Explanation of Request: Construction of a new manufacturing facility for Sintavia.

**RE: SITE PLAN REVIEW – N.E. Corner of SW 25th Avenue & North of SW 39th Street
FILE NUMBER 17-DPV-33**

Please find below the Site Plan Review case review comments and our written responses for the referenced project.

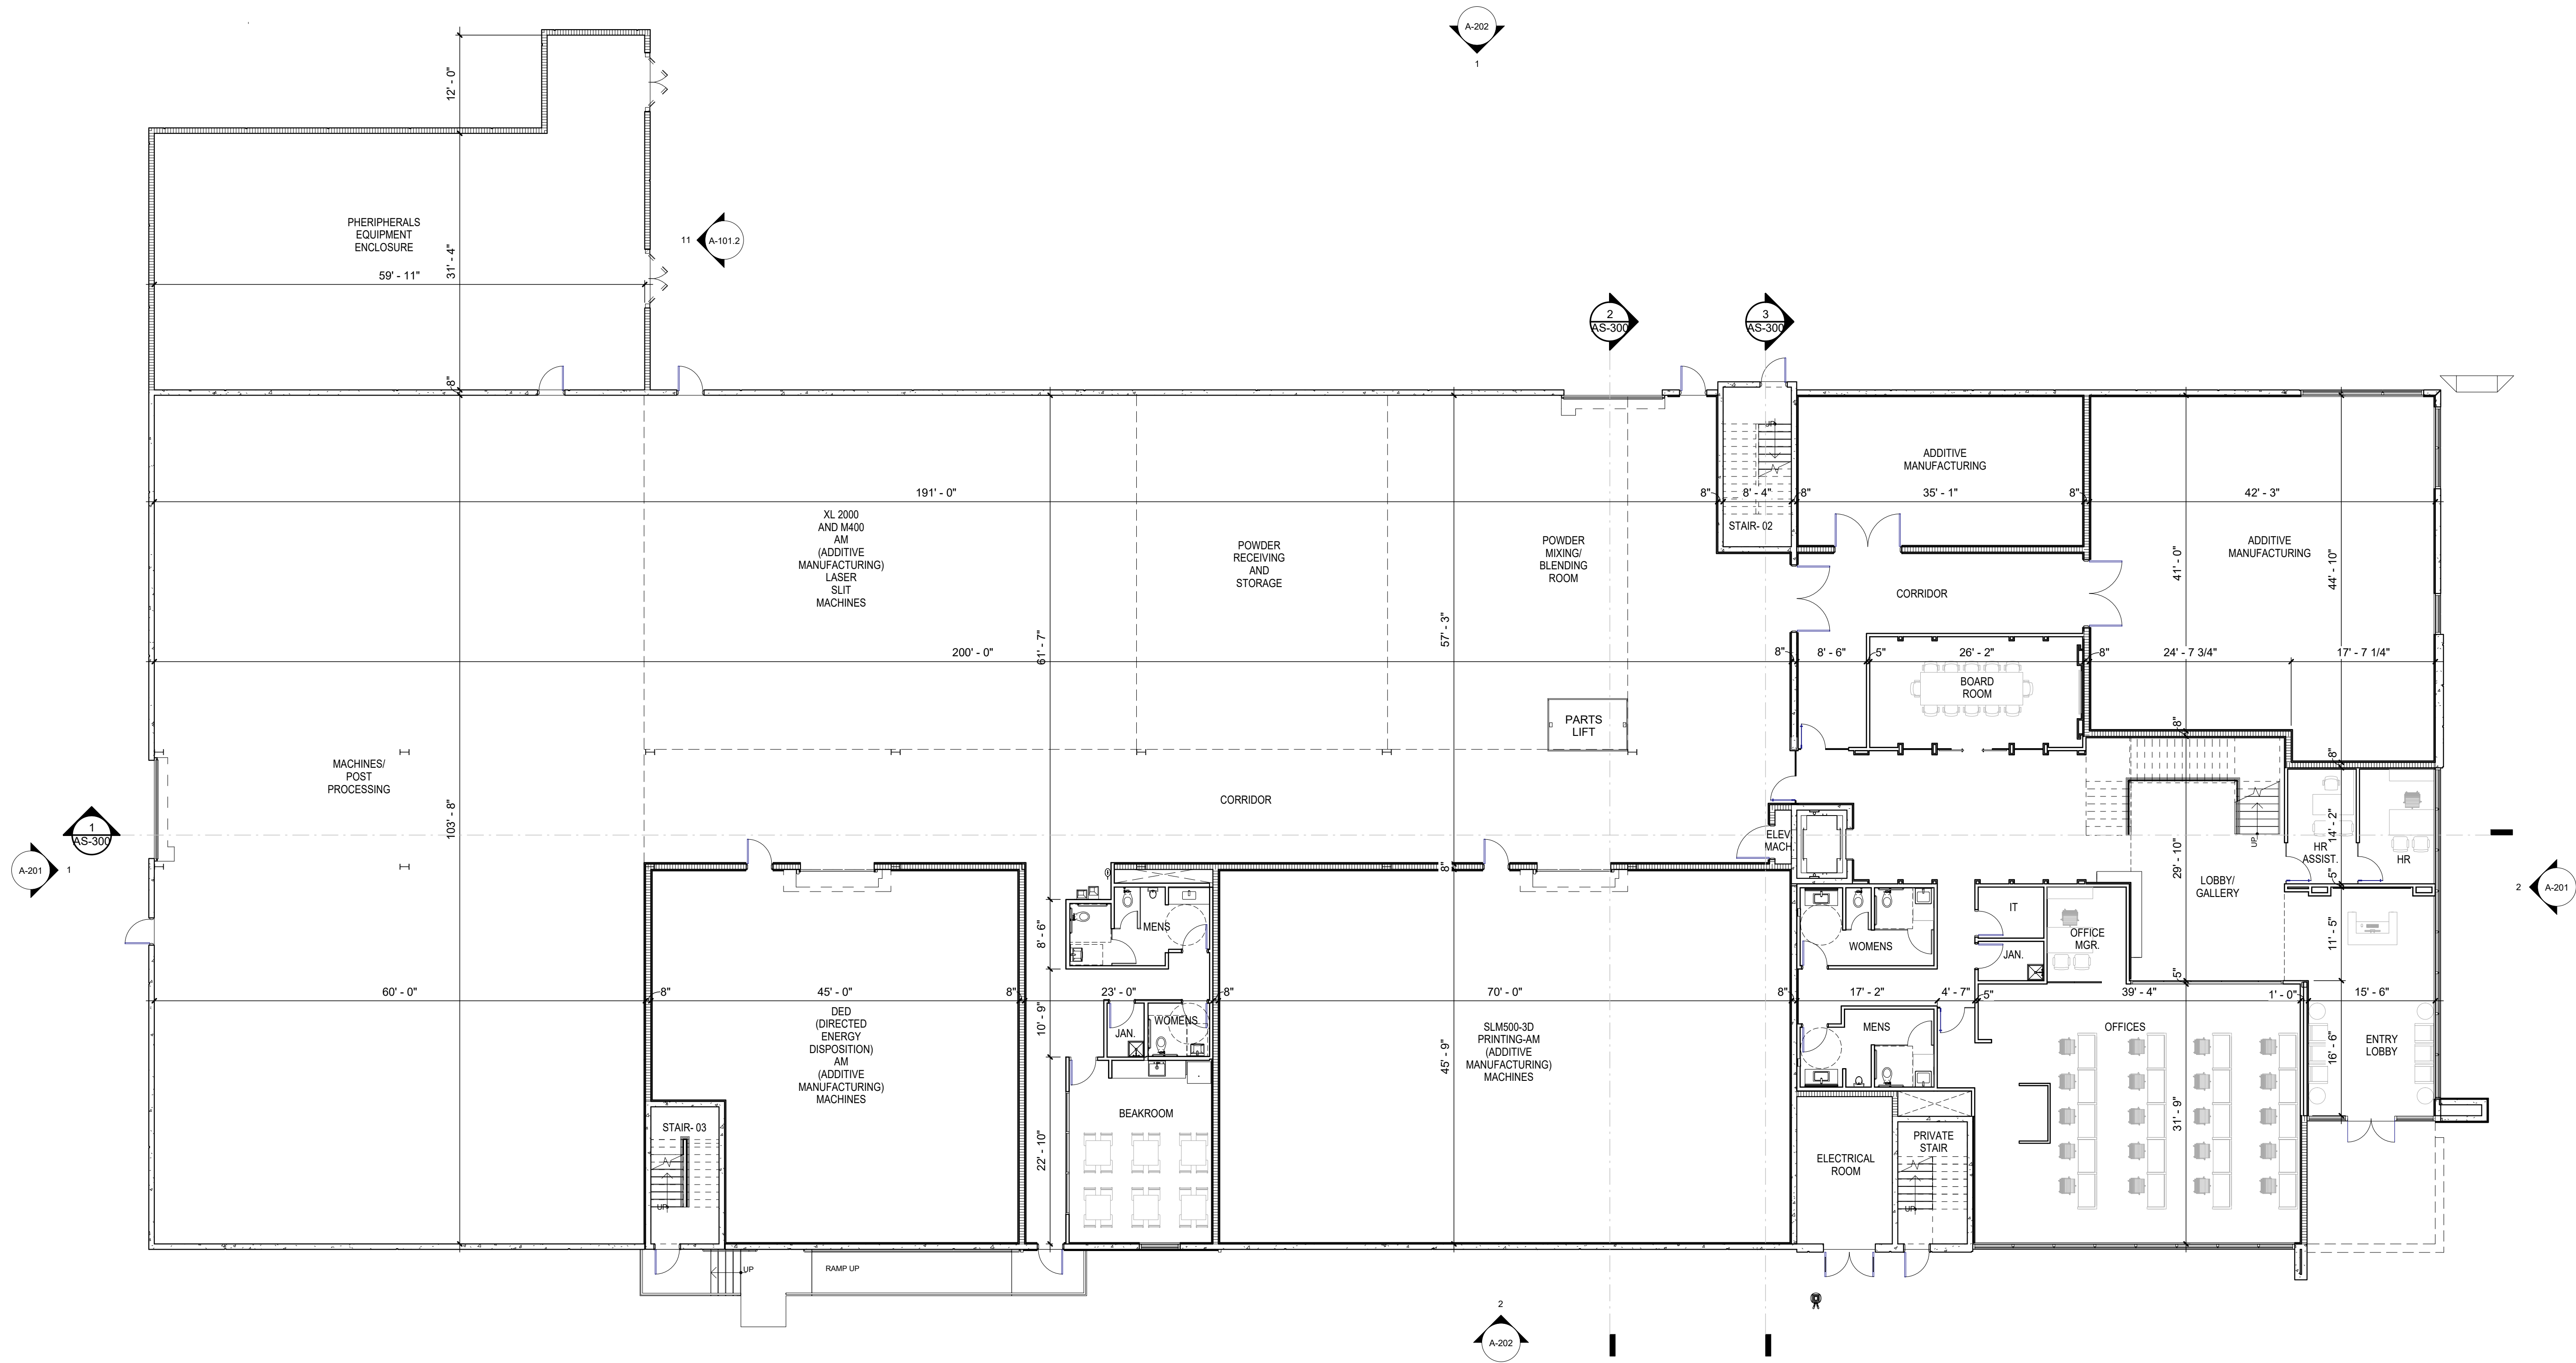
1. Dimension all terminal islands and provide square footage. Each island shall contain a minimum of 190 sq. ft. of pervious area and shall measure (back of curb to back of curb) the same length as the adjacent parking stall.

2. Parking stalls shall be 8.5 x 19 feet long or 17 feet with a two foot grass overhang. Dimension stalls and revise as necessary. Two foot overhang does not count towards landscape calculations; depict two foot overhang with dashed line.

3. Provide wheel stops where a curb does not exist.

4. Site Data reflects the Vehicular Use Area is calculated at 20%; it should be calculated at 25% per article 9, section 9.5.C.1.

5. Project is required to install electric vehicle charging station infrastructure, please see Ordinance O-2016-02.

6. Work with Public Works and Engineering Division to ensure adequate and safe access is provided for garbage truck to access garbage and recycling area.

5. Fire department access must be maintained around the parking lot. Our turning radius is as follows: 28'.5" interior radius, 38' centerline of the turning radius, and 45' exterior. 32'.2". Please show turning radius on pg A-101. Width of the access road is OK.

Response: All landscape islands have been revised to comply with this requirement (see Sheet A-101).

Response: *Parking stalls have been revised to comply with this dimensional requirement. In addition, all parking spaces abutting landscape areas will be expanded to include the 2 foot overhang, along with an extruded concrete curb. (see Sheet A-101).*

Response: *Wheel stops have been provided at all stalls that do not have concrete curbs (see Sheet A-101).*

Response: *This was a scribe's error and is actually 25%. See corrected Site Data Calculations (see Sheet A-101).*

Response: *Electrical rough will be provided for a future Vehicle Charging Station, see location at parking on west side (see Sheet A-101 for note on plans).*

Response: *Location of garbage and recycling waste enclosure has direct head-on access. (see Sheet A-101)*

Response: *Turning radius are identified on the Site Plan, Sheet A-101 and are as follows: Interior-41'- 6"; Centerline - 45'-9" & Outside – 50'-0".*

ROOF PLAN

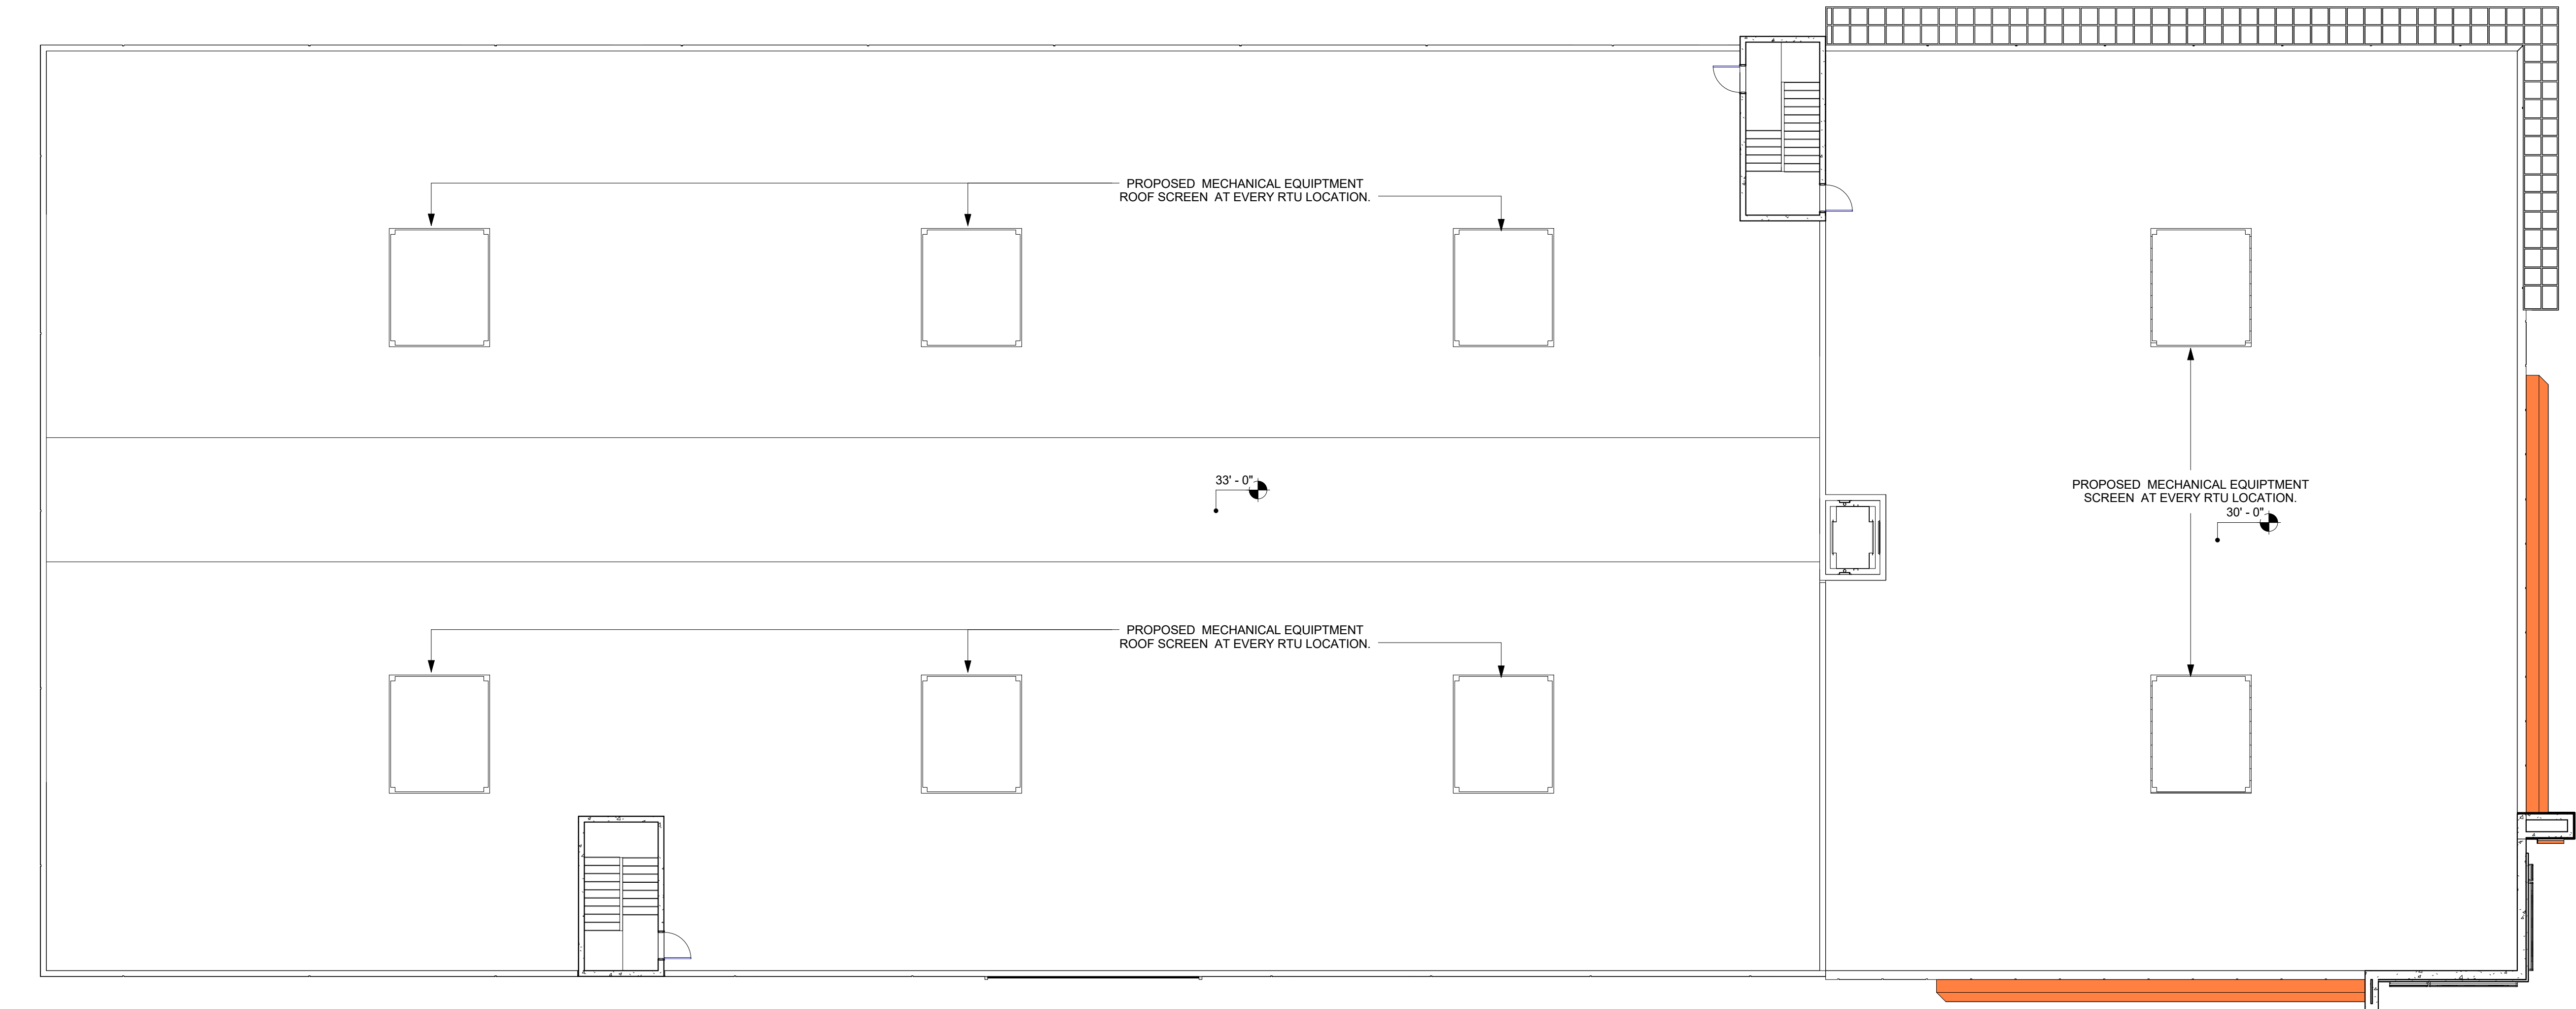
- 6. Indicate the location of mechanical equipment. Include a Roof Plan if located on the roof. If not, include note stating that all mechanical equipment shall be properly screened from public view.

Response: See new Roof Plan (Sheet A-105) showing location of all rooftop equipment. All rooftop mechanical equipment will be independently screened on all 4 sides (refer to revised Exterior Elevation Sheets (A-201 & A-202).

A-201

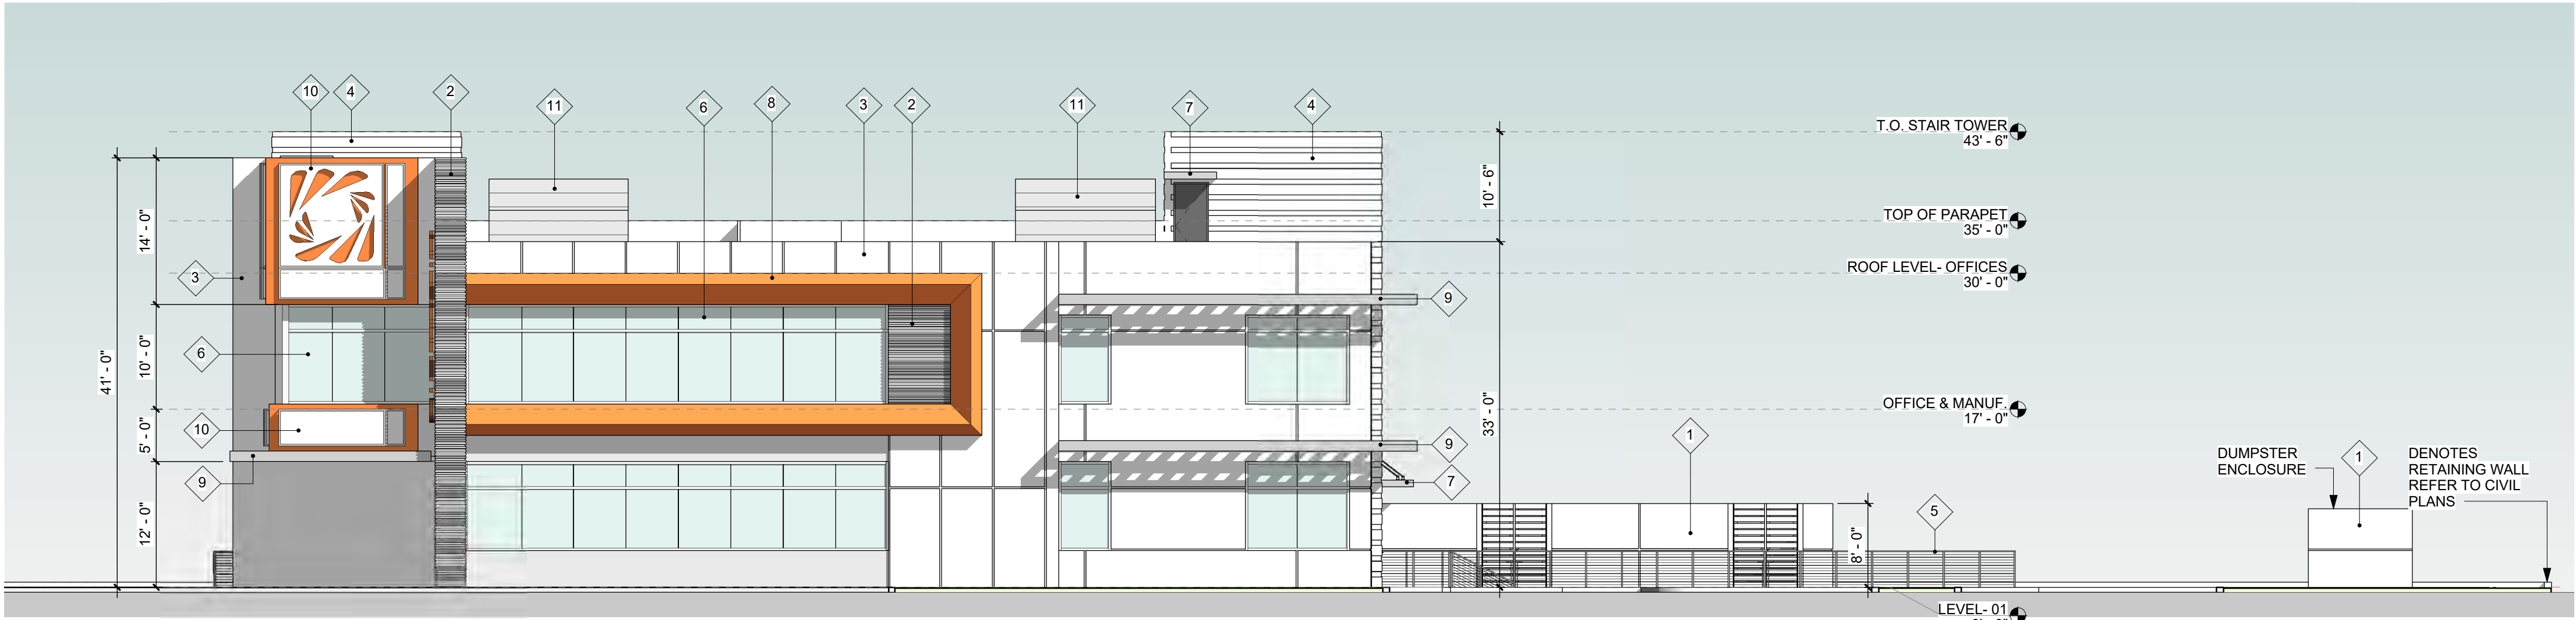
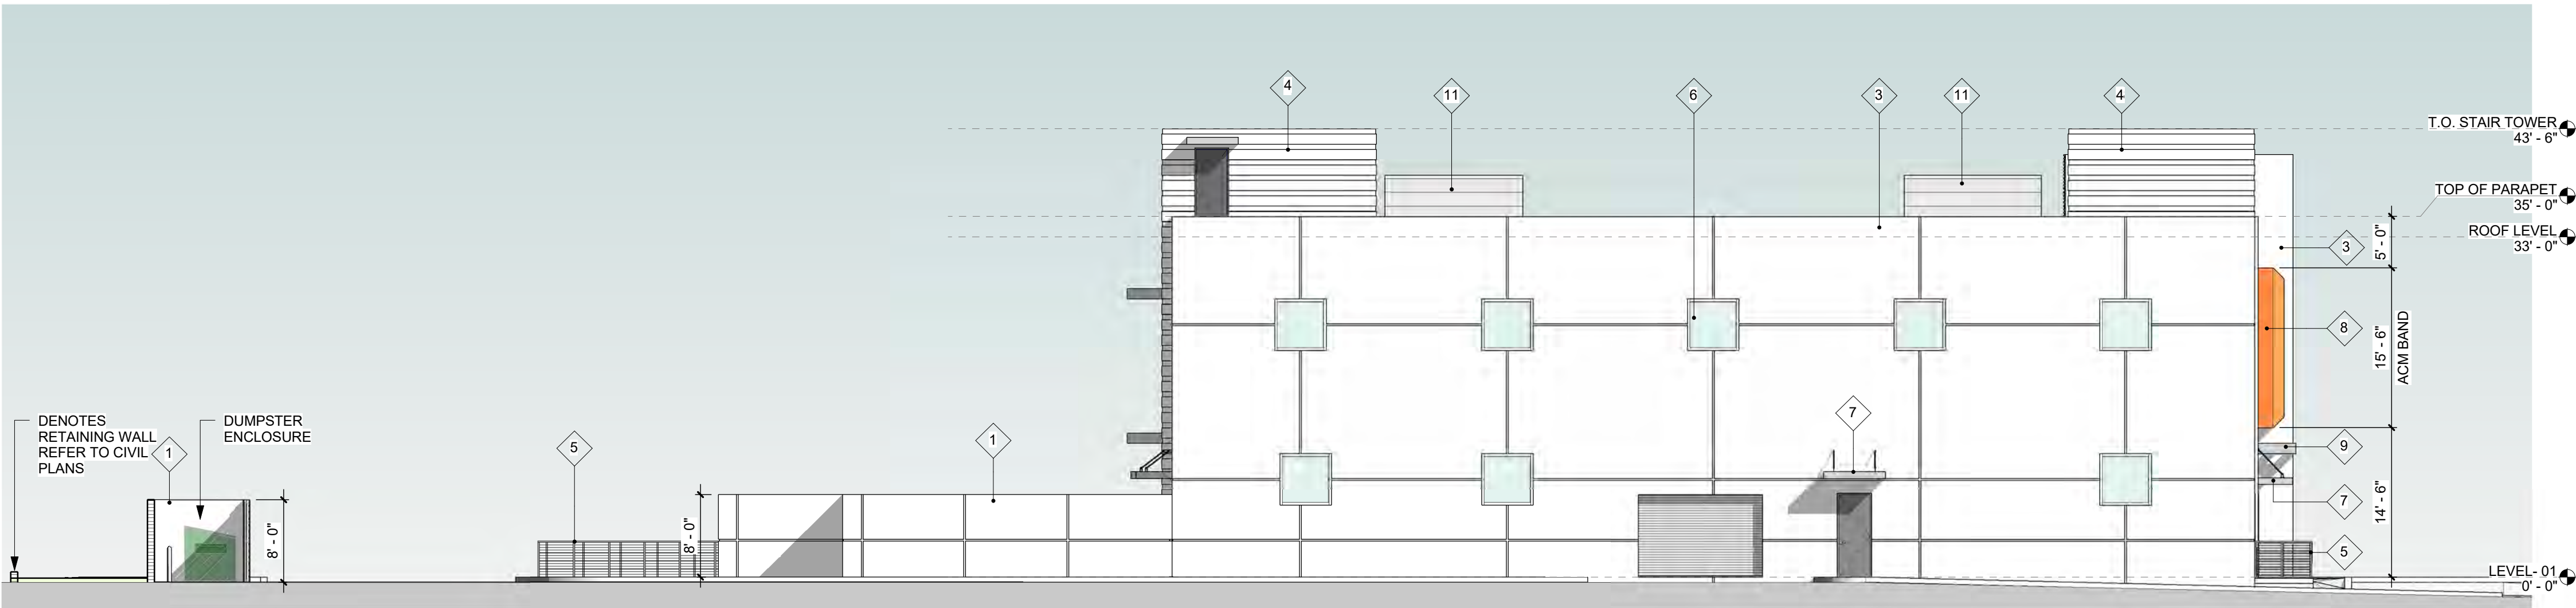
- 8. Provide details and height of all existing and proposed fences, gates, walls, etc. Maximum height of proposed screening wall at the loading area is eight feet. Note on plans.

Response: Heights of equipment enclosures have been indicated on the Site Plan

(Sheet A-101), Site Detail sheet (Sheet A-101.2) and Exterior Elevations (Sheets, A-201 & A-202).
